Access Compliance Report

Public Rights-of-Way

(Curb Ramps)

Intersection ID: 10042138	Main Street: WITHERS_COVE_PARK_DR	Cross Street: N/A	Location: SW
ADA ID: 4692AB3C93A6	Ramp Type: PerpDiag	Initial Pass/Fail: Fail	Overall Compliance: No
Codes/Mitigation Info/Possible Solution		Field Measurements/Component Compliance	
Severity Score: 46.25

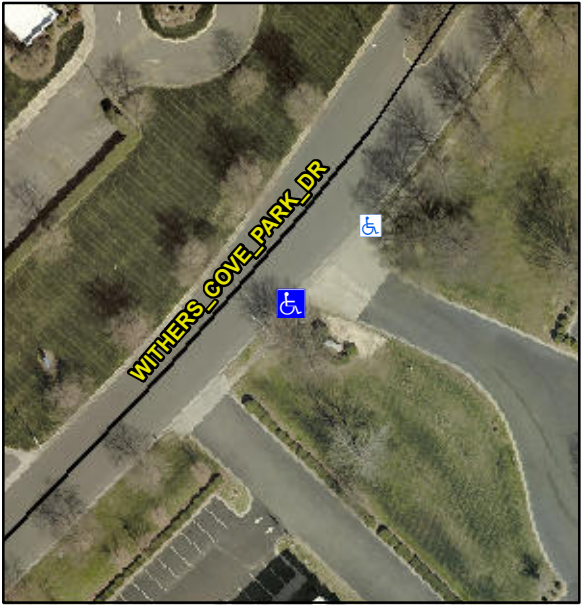
Possible Solutions:		Compliance	Description	Data	Compliance	Description	Data
	Remove & Replace Curb Ramp With Two New Directional Ramps or Equivalent.		N/A	Ramp Length (in)	60.0	No	Ramp Slope (%)	8.8
<p>Surveyor Notes:</p> <p>N/A</p> <p>PROW/ADA:</p> <p>Not Found, R304.5.1, R304.2.2, R304.5.3</p>			No	Ramp Width (in)	40.0	No	Ramp XSlope (%)	7.6
			N/A	Flare Type LT	N/A	N/A	Flare Type RT	N/A
<p>Street 1 Name</p> <p>ENTRANCE</p> <p>Stop Condition-Street 2</p> <p>None</p> <p>Street 2 Name</p> <p>WITHERS COVE PARK DR</p> <p>Stop Condition-Street 1</p> <p>None</p>			N/A	Flare Slope LT (%)	N/A	N/A	Flare Slope RT (%)	N/A
			N/A	Flare Traversable LT?	N/A	N/A	Flare Traversable RT?	N/A
<p>Total Cost:</p> <p>\$ 3200.00</p>			N/A	Landing Length (in)	N/A	N/A	DWS Provided?	N/A
			N/A	Landing Width (in)	N/A	N/A	DWS Contrast?	N/A
			N/A	Landing Slope (%)	N/A	N/A	DWS Length (in)	N/A
			N/A	Landing X Slope (%)	N/A	N/A	DWS Full Width?	N/A

N/A	Landing Curb? (Y/N)	N/A	N/A	DWS Offset (in)	N/A
			N/A	Shared Landing?	N/A			
			N/A	Gutter Ponding?	N/A	N/A	Gutter Slope (%)	N/A
			N/A	Gutter Lip Ht (in)	N/A	N/A	Gutter X Slope (%)	N/A
			N/A	Painted X Walk1?	No	N/A	Painted X Walk2?	No
				X Walk 1 Direction	To NE		X Walk 2 Direction	To NW
			N/A	X Walk 1 Width (in)	N/A	N/A	X Walk 2 Width (in)	N/A
				X Walk 1 Slope (%)	2.3		X Walk 2 Slope (%)	2.7
				X Walk 1 X Slope (%)	2.8		X Walk 2 X Slope (%)	2.6
			N/A	Ramp inside XWalk1?	N/A	N/A	Ramp inside XWalk2?	N/A
				Road Slope (%)	3.8	N/A	Clear Space?	N/A
				Road X Slope (%)	0.0	N/A	Clear Space to XWalk (in)	N/A
			N/A	Any Obstructions?	N/A	N/A	Storm Grate/Utility Hazard?	N/A
				Obstruction Type			Storm Grate/Utility Type	
						N/A		N/A
						Yes	Surface Condition? (G/P)	Good
